Re: Ecology Response Letter: Evaluation for the Potential for Subsurface Vapor
Intrusion of the Interior Environments Building, dated July 17, 2006

RE: Evaluation of the Potential for Subsurface Vapor Intrusion
at the Interior Environments Building

Evaluation of the Potential for Subsurface Vapor Intrusion at the Interior Environments Building

Re: Ecology Comments on the Work Plan for Evaluation of Sub-Surface Vapor Intrusion at the Interior Environments Building, dated April 17, 2006

SAMPLE LOCATIONS
FIGURE 2-1

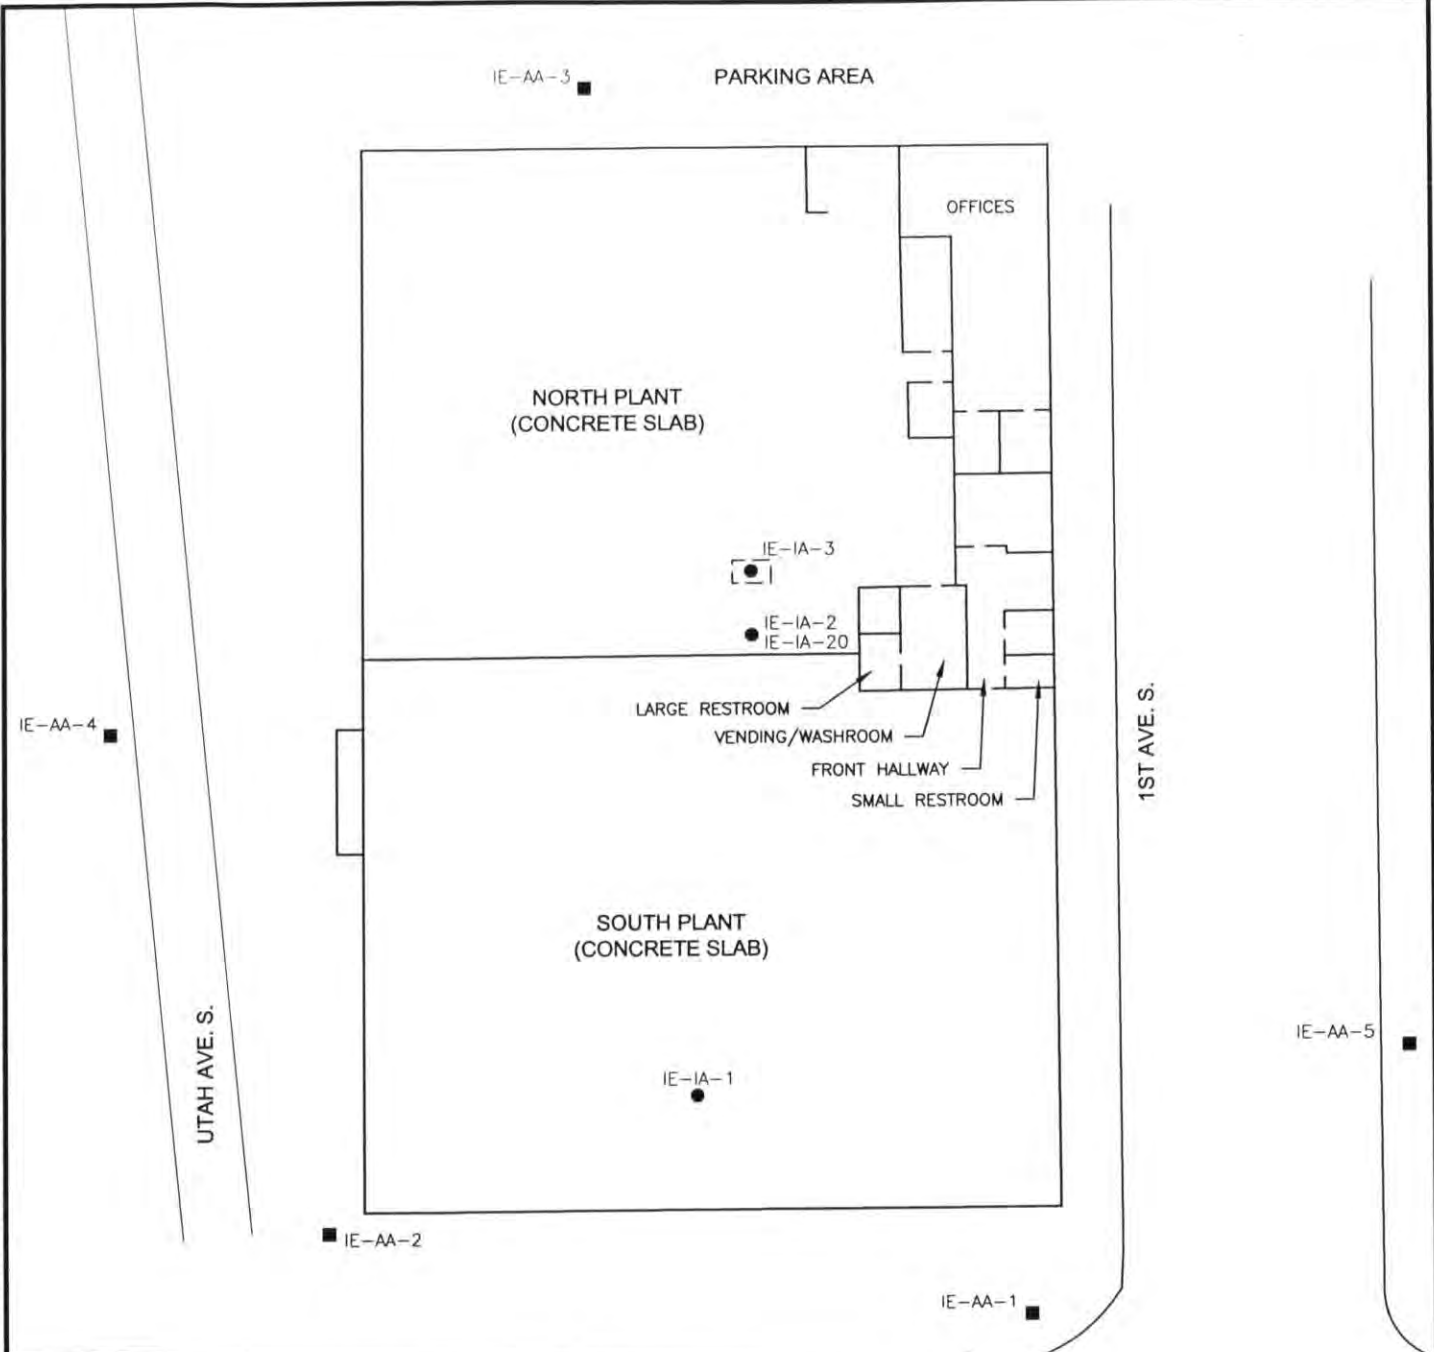
7. Section 2.1, page 2-1, paragraph 1 and Figure 2-1. Crawlspace sample location IA-3 should be located below/inside the most southerly floor *opening*, the one closest to the wall separating the north and south shop spaces.

Please see our attached mark-up of Figure 2-1.

9. Section 2.1, page 2-1, second paragraph and Figure 2-1. It is reasonable to sample ambient air at AA-1 at a height corresponding to 5-8' above ground surface if the wind is coming from the south and the big doors at the south end of the building are open. Otherwise (if the doors are closed), the height should correspond to where we think the outdoor air inlet is. If the building air intake location is on the roof, for example, we would want to position the ambient air sample inlet as high (8-10 foot minimum) as the roof and/or, horizontally, several yards away from and upwind of the building.

In addition, the AA-2 canister should be placed as far south as possible from the Interior Environments building and have the inlet 8-10 feet above ground, to represent ambient air that is likely being pulled into the building roof air intake vents and to minimize the collection of automobile exhaust. An alternative is to locate AA-2 at the southeast corner of the intersection of Dawson and Utah Streets and again locate the inlet 8-10 feet above ground, to represent ambient air that is likely being pulled into the Interior Environments building roof air intake vents and to minimize the collection of automobile exhaust.

Please see our attached mark-up of Figure 2-1.
